ADDITIONAL PROCESS INFORMATION
(LETTERS TO DEQ, 5/31/07 AND 6/13/07)

HOKU MATERIALS, INC.
3500 MT/YEAR POLYSILICON PLANT
POCATELLO, IDAHO

RE: Response to Questions from Review of Hoku Materials, Inc PTC Application

Typical Reactor (CVD) Area

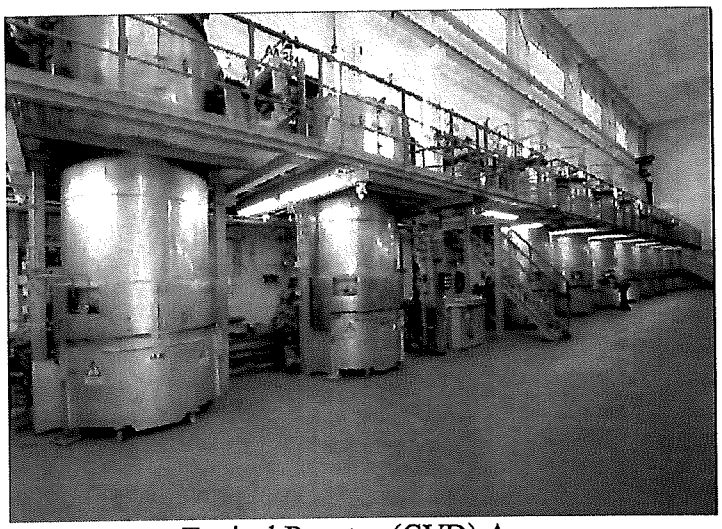
Part 1) Hoku states that emissions limits on the Mitsubishi plant are representative of emissions from the proposed operations in Pocatello. Hoku also states that Mitsubishi's potential to emit was adjusted for Hoku's operation to obtain emission estimates. What emission units are permitted at the Mitsubishi plant?

Part 5) In Hoku's application it is stated emissions limits on the Mitsubishi plant are representative and were used to estimate emissions from Hoku's lab scrubber, chlorosilane scrubber and relief vent scrubber. Please describe in as specific terms as possible why these emission limits represent emissions from Hoku's operations.

Once analyzed, the trichlorosilane (TCS) liquid is vaporized, mixed with hydrogen gas and sent to a reduction or Chemical Vapor Deposition (CVD) furnace. During the chemical vapor deposition process, silicon from the gas stream is deposited on the surface of electrically heated polysilicon seed rods. The reduction furnace is precisely controlled to grow the polysilicon rod to a predetermined diameter. This process varies but generally ranges from 5-8 days. The Mitsubishi and Hoku CVD processes are essentially the same. A picture of typical polysilicon reactor and reactor area is shown below.

The emission units for this area include each reactor that Hoku has in its plant. Mitsubishi would have something similar. Each reactor purge goes to the chlorosilane vent scrubber and is a main source for the emissions from this area. The scrubber types are not selected but may be venturi, spray chamber or a combination. This is very similar to the Mitsubishi process and other polysilicon manufactures that employ a TCS based process. The factored estimate that was used to calculate the Hoku emissions is based on the plant capacity of the polysilicon production capabilities (i.e. comparing Mitsubishi's 1,800 MT plant to Hoku's 2,000MT plant). Most reactors today have the similar production capacities and chamber volumes and thus must be opened at approximately the same frequency releasing similar components and volumes. It is more a function of production capacity. This is the only emission unit in this area.

Additional Vent Gas Recovery (VGR) Details

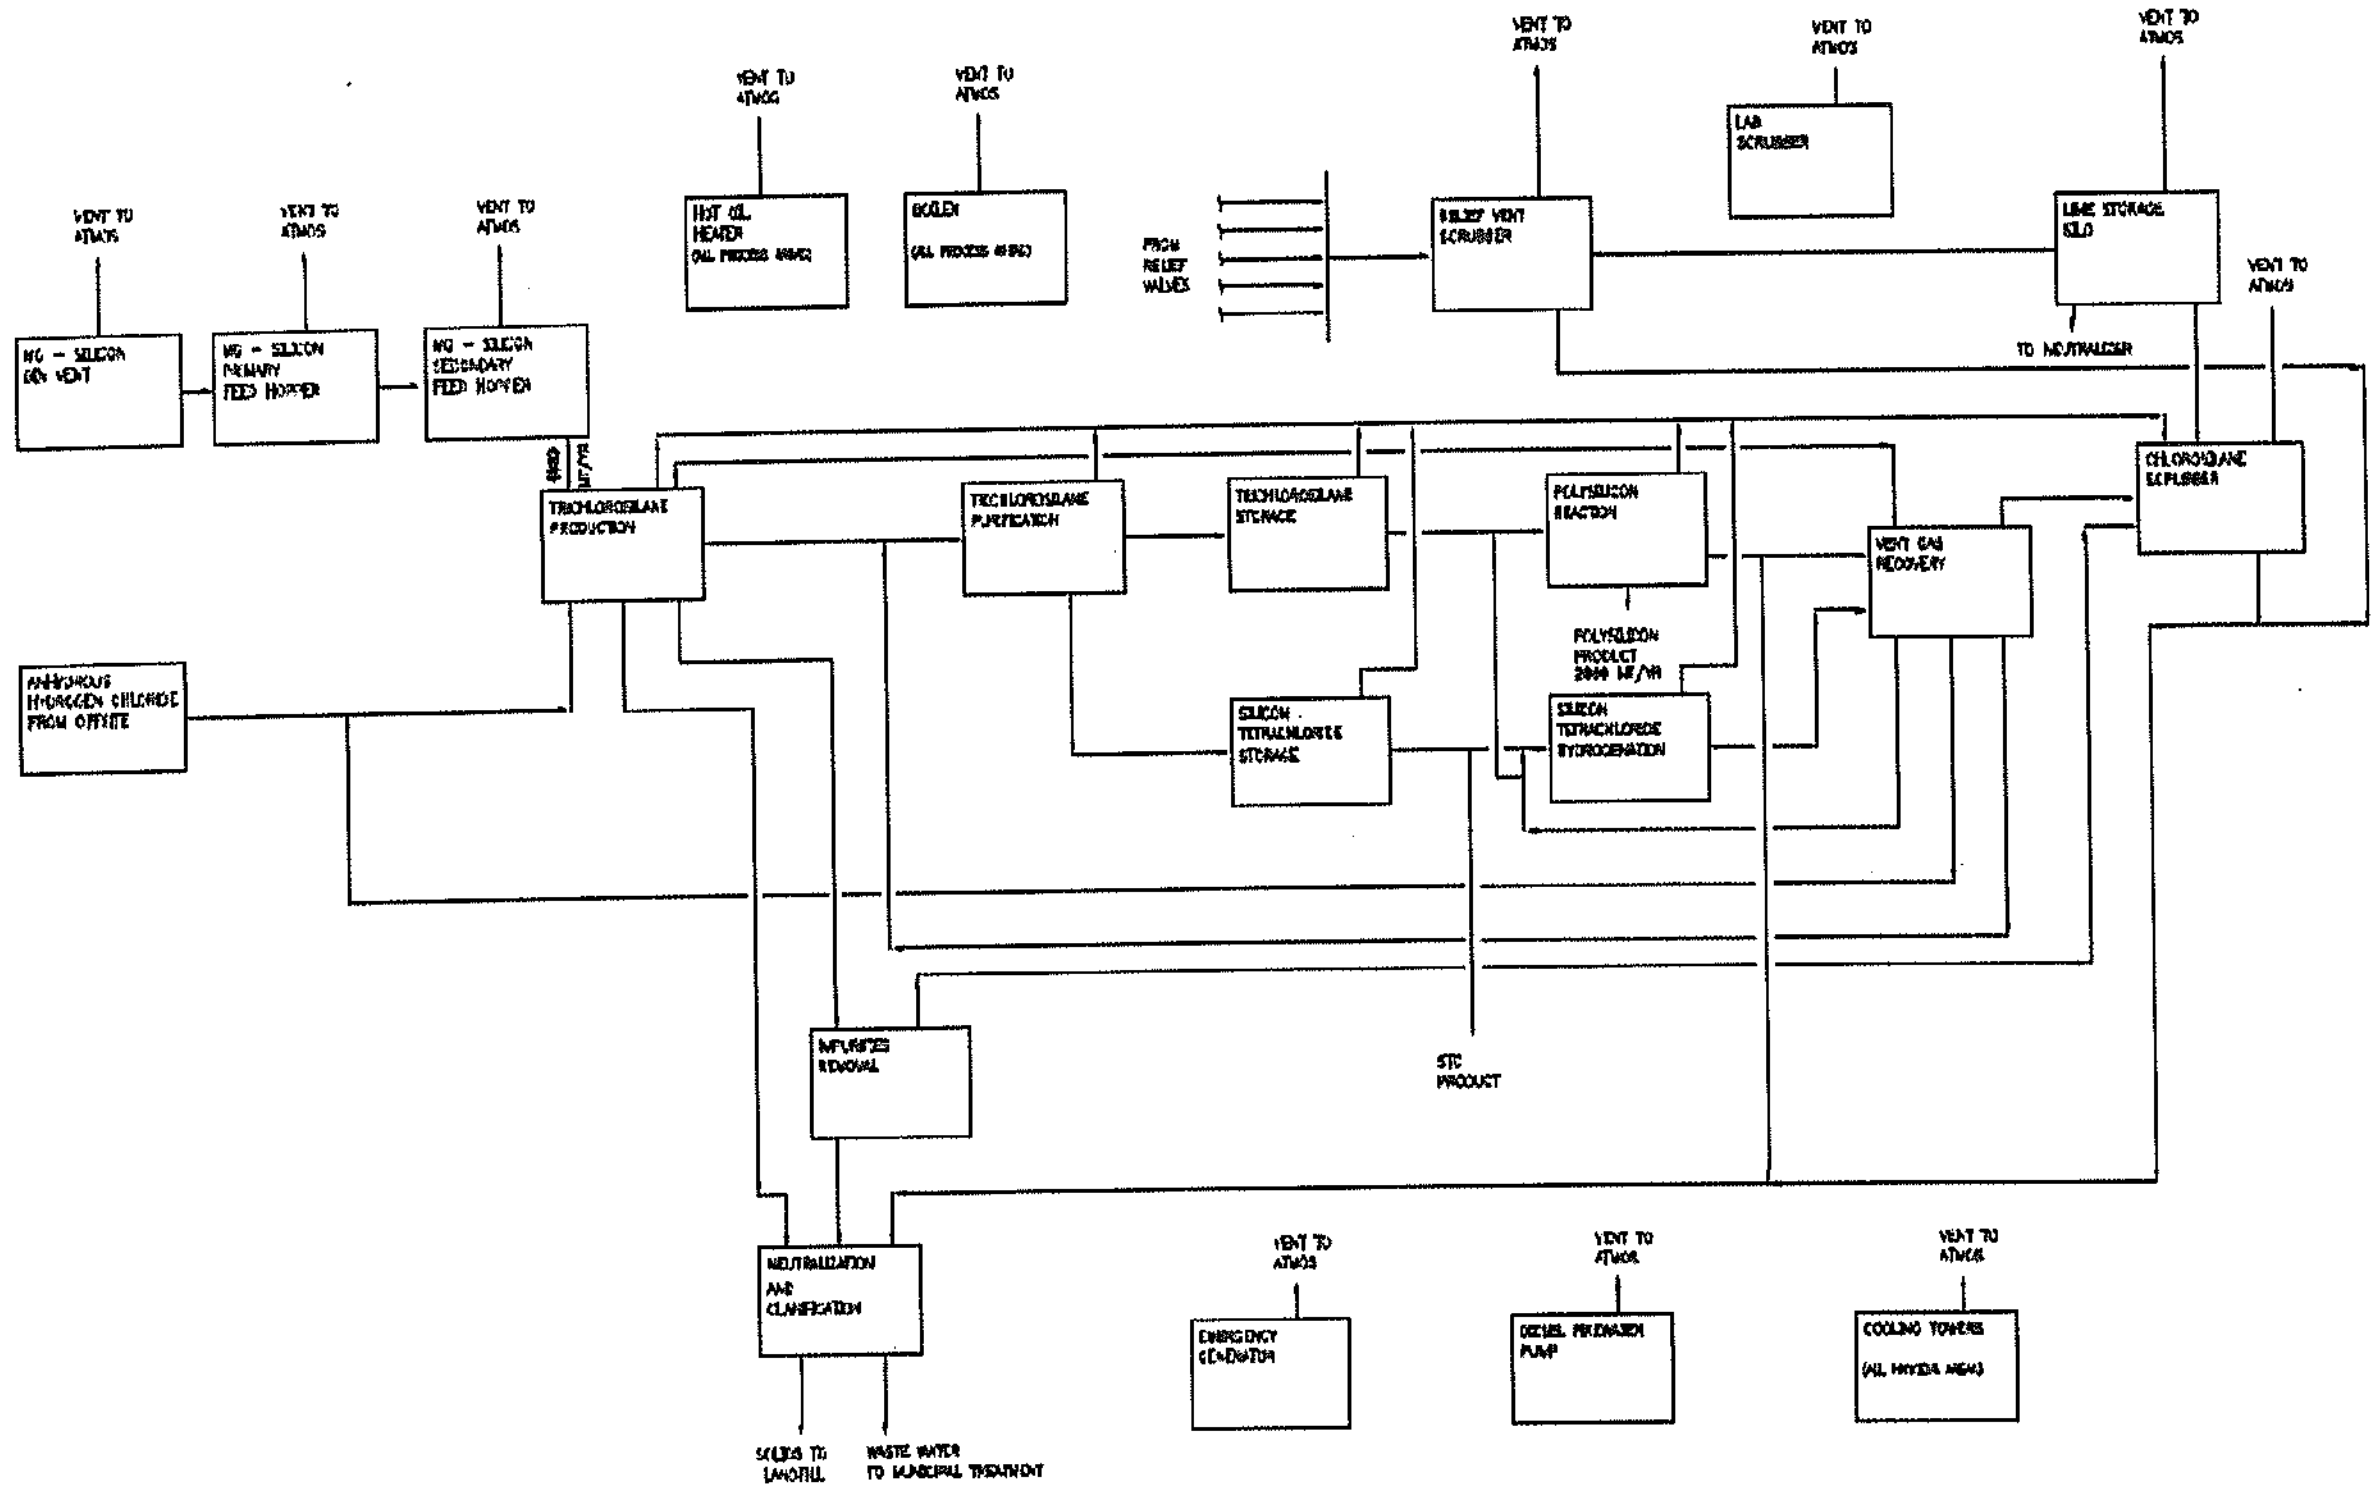
Part 1) The vent gas recovery unit is stated to remove liquid chlorosilanes, hydrogen chloride gas and hydrogen gas from the vent gas stream prior to the chlorosilane scrubber. Please describe in detail the physical and/or chemical processes that are employed to accomplish the removal of chlorosilanes and hydrogen chloride gas.

Part 2) It appears that the proper operation of the vent gas recovery unit is critical in assuring that chlorosilanes and hydrogen chloride gas is not emitted in quantities greater than what is stated in the application. How is the vent gas recovery unit operated and maintained? Please see the explanation below.

Part 3) What are the operating parameters that must be maintained to assure the vent gas recovery unit operates as designed (temperature, pressure drop, flowrates, etc.)

Part 4) If the vent gas recovery system is not critical in limiting emissions of chlorosilane and hydrogen chloride please describe how the chlorosilane scrubber is designed to abate emissions of these pollutants that would occur without the vent gas recovery system operating as designed.

Response to Part 1) There may be a misunderstanding of the operation of the vent gas system. In general, the vent gas recovery unit recycles all gases exiting from the CVD reactors (ie Siemens reactors) and hydrogenation reactors.

Response to Part 2) The Vent Gas Recovery recycles all chemicals from the reactors back into other parts of the process. It is not essential to operate the vent gas recovery unit properly to ensure that the chlorosilane and hydrogen chloride gas is not emitted. It is a recycle unit for the plant and not a pretreatment unit for the scrubbers. The unit is linked with the reactors to control the quality of materials returned/recycled. Shut down of the VGR does not mean that chlorosilanes or HCl are released. Shutdown of the VGR unit

Response to Part 3) All the details of operation of this unit are difficult to provide based on the proprietary nature of the unit. However, CDI has designed several of these units and the control system to operate it. As such Hoku intends to monitor temperature, pressure, flow rates and other parameters to ensure the proper operation of the unit. More details are provided below.

Response to Part 4) There is no continuous flow to the vent gas scrubber from the vent gas recovery system. As such if the VGR system is down there is no additional load to the scrubber system. Hoku believes there is a misunderstanding of its process. Hopefully, the details in this response document help provide clarity. If not, please contact Karl Taft for further information.

The Vent Gas Recovery recycles all chemicals from the reactors back into other parts of the process as shown on the block flow diagram below (this is the same diagram submitted with the application on May 15, 2006).

There are no continuous vents from the VGR to the scrubbers. VGR uses typical processing equipment including distillation columns, reboilers, condenser, heat exchangers, pumps, compressors and absorbers to separate the various chemicals for re-use in the process. A more detailed description of the VGR unit is below.
